AES-O-NRC-10-00349-0

AREVA Enrichment Services LLC
Eagle Rock Enrichment Facility
NRC Docket No: 70-7015

Subject: AREVA Enrichment Services LLC - Eagle Rock Enrichment Facility, Supplemental Sage Grouse Survey Report

Markup Pages for the EREF Environmental Report

Figure 3.5-4 **Rev. 3**

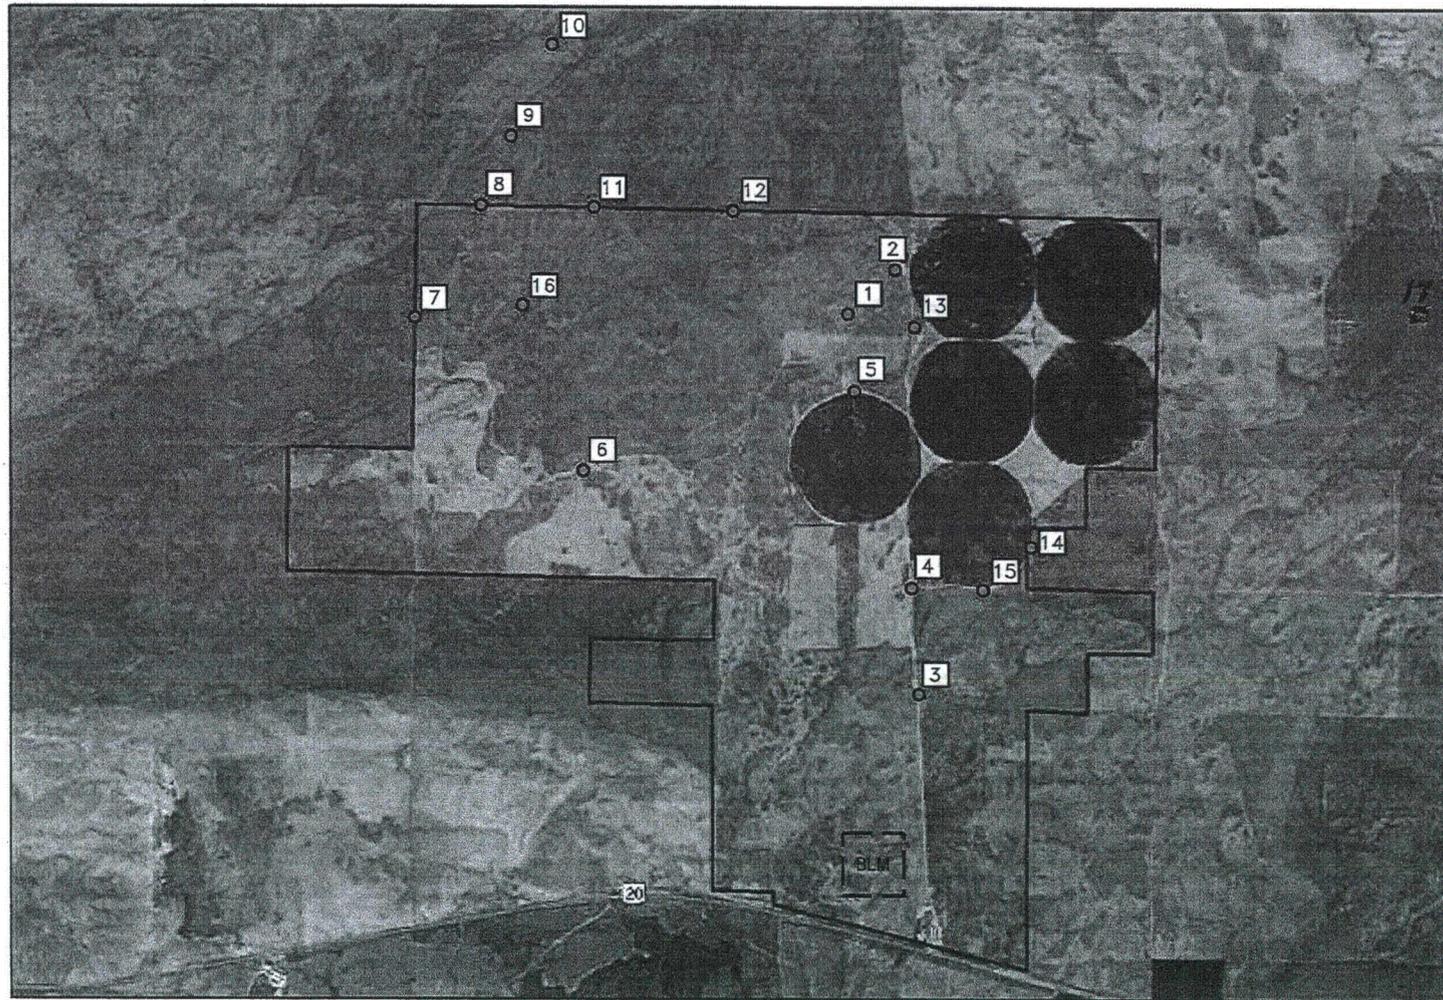
Ecological field surveys at the proposed site were conducted in May 2008, June 2008, October 2008, January 2009, and April 2009. Wildlife and vegetation transects were used to obtain information on vegetation cover, mammals, birds, reptiles, and amphibians occurring on the site. The locations of the transects and data collection points for the June 2008 and October 2008 surveys are shown in Figure 3.5-1, June and October 2008 Vegetation and Animal Survey Transect Locations and Habitat Map. The locations of the transects and data collection points for the January 2009 surveys are shown in Figure 3.5-2, January 2009 Animal Survey Transect Locations and Habitat Map. The locations of the transects and data collection points for the April 2009 surveys are shown in Figure 3.5-3, April 2009 Animal Survey Transect Locations and Habitat Map. THE APRIL 2010 SAGE GROUSE SEARCH POINTS ARE SHOWN IN FIGURE 3.5-4, APRIL 2010 SAGE GROUSE SURVEY POINT LOCATIONS.

***Note: The April 2010 surveys were only conducted for greater sage grouse. No birds were observed or heard, and no sign observed (e.g., tracks, scat, etc.) at search points 5, 14 and 15.

FIGURE H-8 **Rev. 3**
 April 2010 Sage Grouse Survey Point Locations
 Transmission Line Route
 Bonneville Substation to EREF
**EAGLE ROCK ENRICHMENT FACILITY
 ENVIRONMENTAL REPORT**

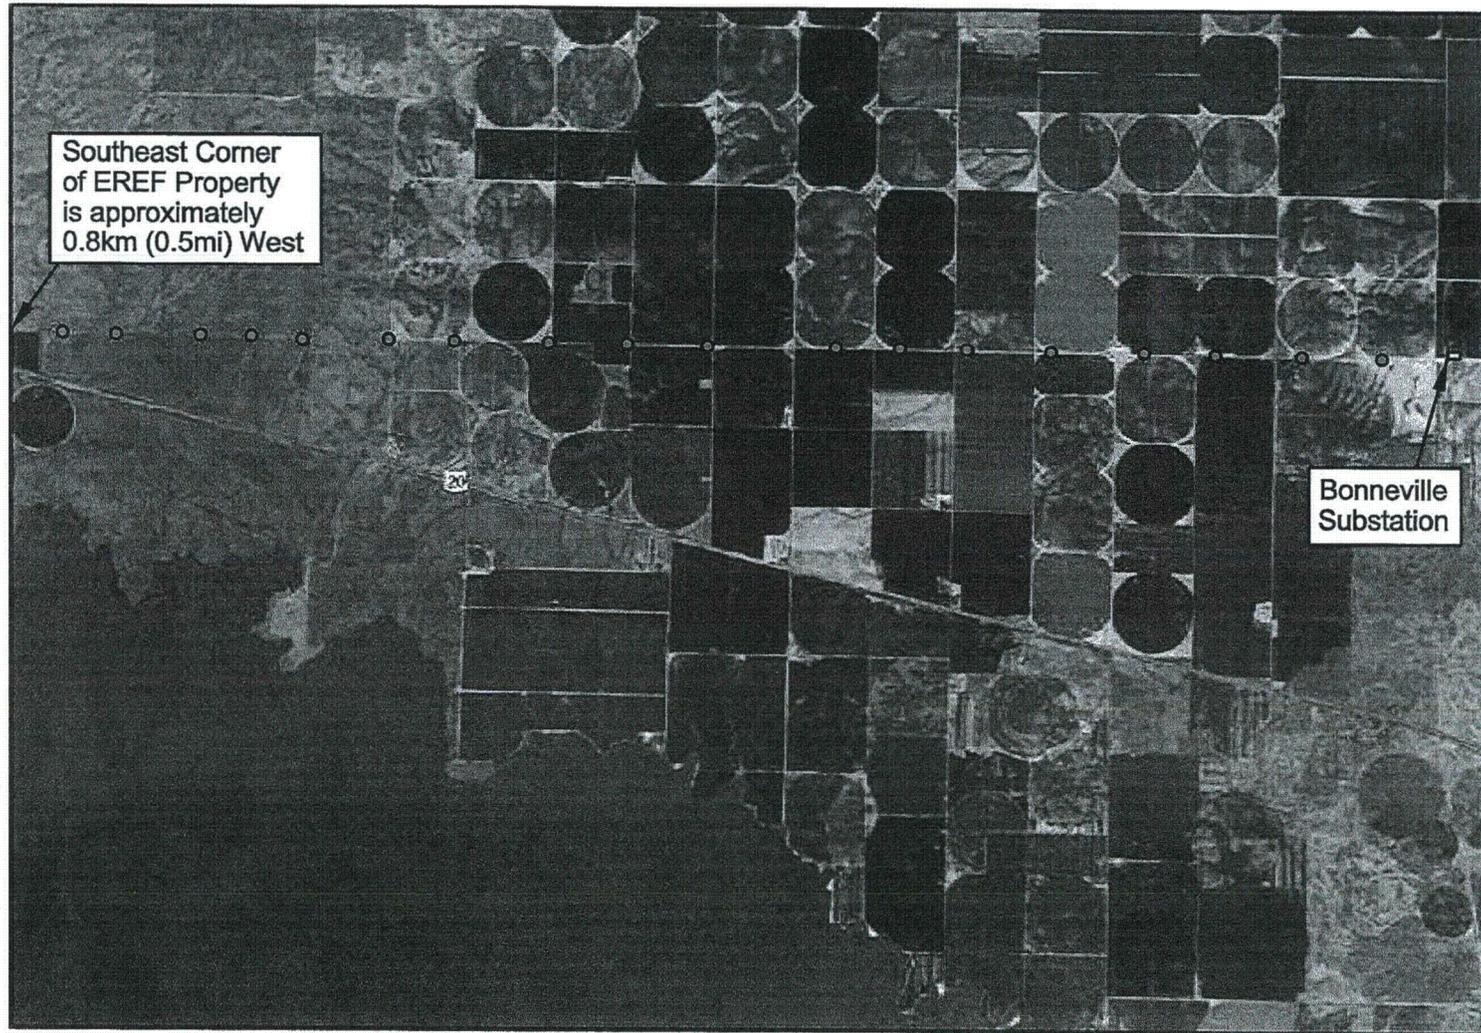
A sage-grouse lek survey ^{WERE} was performed for the proposed EREF in May 2008; during this ^{AND APRIL 2010} survey ^{use} no leks were identified within the bounds of the survey area (MWH, 2009). During the ^{AND APRIL 2010} October and November 2009 surveys, no sign of sage-grouse use (scat) was observed within the proposed transmission line corridor. The low volume of use of habitat within the survey corridor was not unexpected due to the limited amount of suitable sagebrush habitat within the corridor. ^{NORTH WIND 2010}

A separate survey ^{WERE} for sagebrush habitat, sage-grouse, and other sensitive species was performed for the EREF Area of Potential Effect (refer to the EREF ER Sections 3.5 and 4.5 and the Sage Grouse Survey Report prepared for the EREF ER). ^{DURING MAY 2008,} Although no sage-grouse or sage-grouse sign was observed on the EREF property, one sage-grouse was observed on BLM-administered lands north of the EREF property and a second sage-grouse was heard and feathers were found at a different location north of the EREF property. ^{INSERT FOR ER APP. H, SECTION 3.10.2}
